Dart Aerospace Ltd. Wednesday, 30/07/2008 9:00:49 AM Date: User: Julie Lecocq **Process Sheet** : BUBBLE WINDOW, RH : CU-DAR001 Dart Helicopters Services **Drawing Name** Customer **Job Number** : 40803 **PROTOTYPE** : 11394 **Estimate Number** : D32692 **Part Number** P.O. Number · D3269 : 30/07/2008 **Drawing Number** This Issue S.O. No. : : N/A : NC **Project Number** Prsht Rev. : THERMOFORMING : D : // Type **Drawing Revision** First Issue : 40743 Material **Previous Run** Qty: 3 // Um: : 06/08/2008 **Due Date** Written By 1st 060730 Checked & Approved By KJ/JLM Comment A 05.03.22 CERTIFICATE OF CONFORMITY Est B 05.05.09 Added engraving EC Est Rev:06-07-03 As per Rev C JLM REQUIRED Thermoform in-house DL verified by:EC Est C 07.11.06 Est. Rev: D 08.07. 24 As per New Tool **Additional Product** Job Number: Description: Seq. #: HAND FINISH TH HAND FINISHING THERMOFORMING 1.0 08,07,30 Comment: HAND FINISHING THERMOFORMING Set up Clamping Frame and Load Program as per Folio FTA 014 0.177" PLEXIGLAS G CLEAR CAST ACRYLIC SH 2.0 MACRILIC . 125 " PLEXI G Comment: Qty.: 10.0000 sf(s)/Unit Total: 10.0000 sf(s) Mr. 08.07.30 0.177" PLEXIGLAS G CLEAR CAST ACRYLIC SH HAND FINISHING THERMOFOR

DESIG	p	DRAWN BY	DART AEROSPACE LTD HAWKESBURY, ONTARIO, CANADA					
CHEC	(ED	APPROVED /	DRAWING NO.	REV. B				
	W	-	DSI 9329 SHEET	1 OF 1				
DATE			TITLE	SCALE				
06.0	6.26	·	BUBBLE WINDOW INSTALL MOD.	NTS				
Α		06.04.25	NEW ISSUE					
В		06.06.26	CHG TO EFFECTIVE AFTER CHG 002

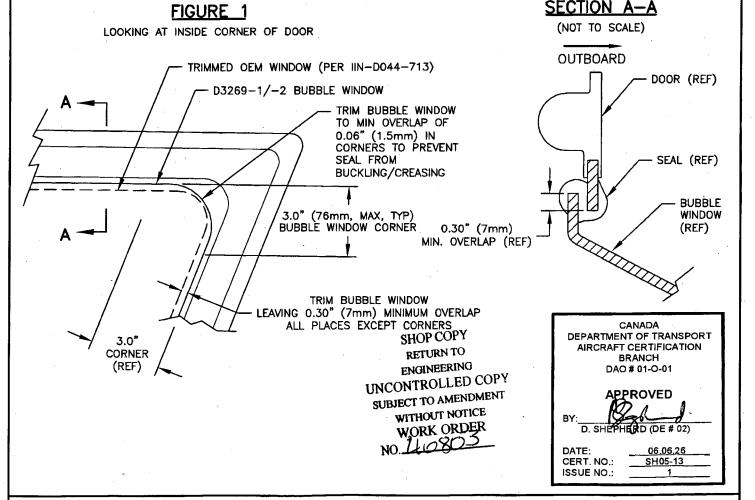
For the D044-713-013/-014 kits supplied after CHG 002, the D3267-1/-2 bubble windows have been supplied untrimmed to allow for easier installation in the field. The installer must trim the windows in accordance with these instructions prior to installation.

- 1) Modify the R44 crew door per items 3.2.1 and 3.2.2 of Installation Instructions IIN-D044-713 Rev.A.
- 2) Fit and trim the D3269-1/-2 Bubble Window to match the cutout in the door as follows: The bubble window must be a minimum of 0.30" (7mm) larger than the cutout in the OEM window as shown in the figure below. However, in the corners of the window, it is acceptable to trim a 0.06" minimum overlap (1.5mm) to help prevent the D2126-0903 Seal from buckling/creasing in the corners. The edge of the bubble window must be deburred to a smooth finish.
- 3) Continue installing the bubble window per items 3.2.3 through 3.2.5 of the installation instructions

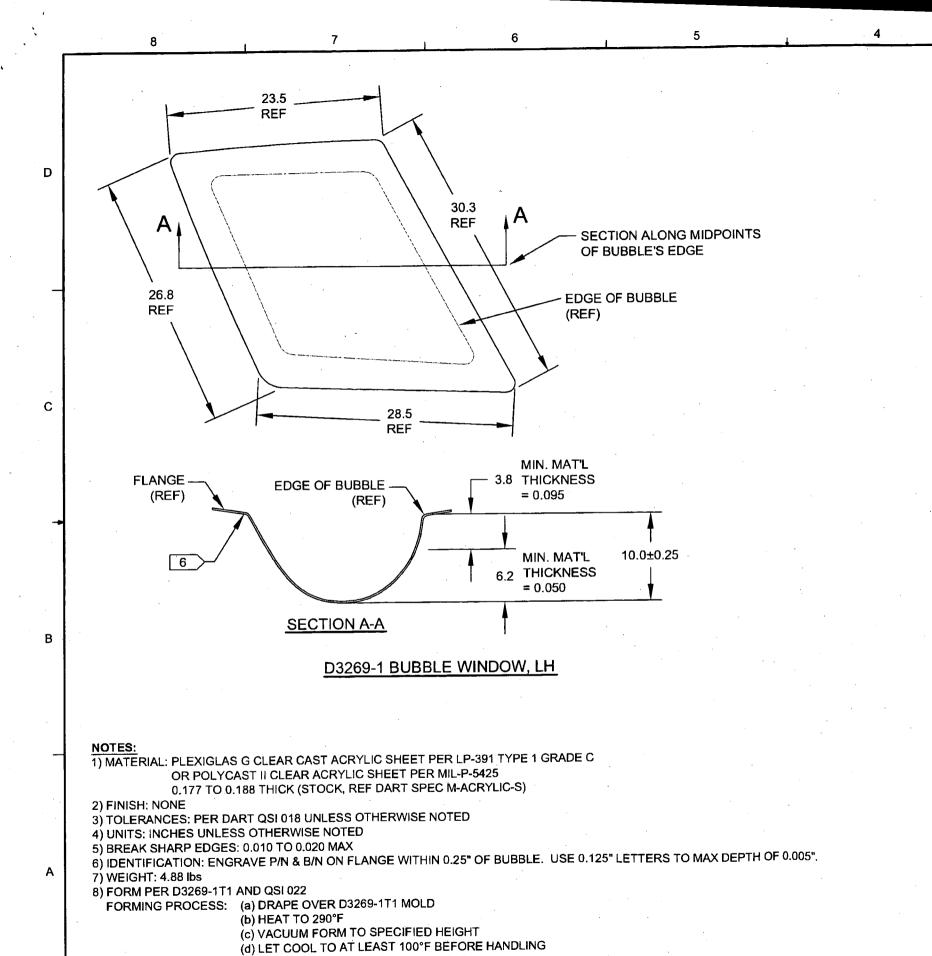
REFORMAT, CHG OVERALL REF DIMS, CHG FORMING PROC (A8-1,A8-2), MIN WALL WAS 0.100 NOW 0.095 08.02.13 (C6-1,C7-2) 06.06.22 NO LONGER TRIMMED 05.03.10 UPDATE MATERIAL SPEC. 05.02.18 NEW ISSUE DATE DESCRIPTION DART AFROSPACE LTD
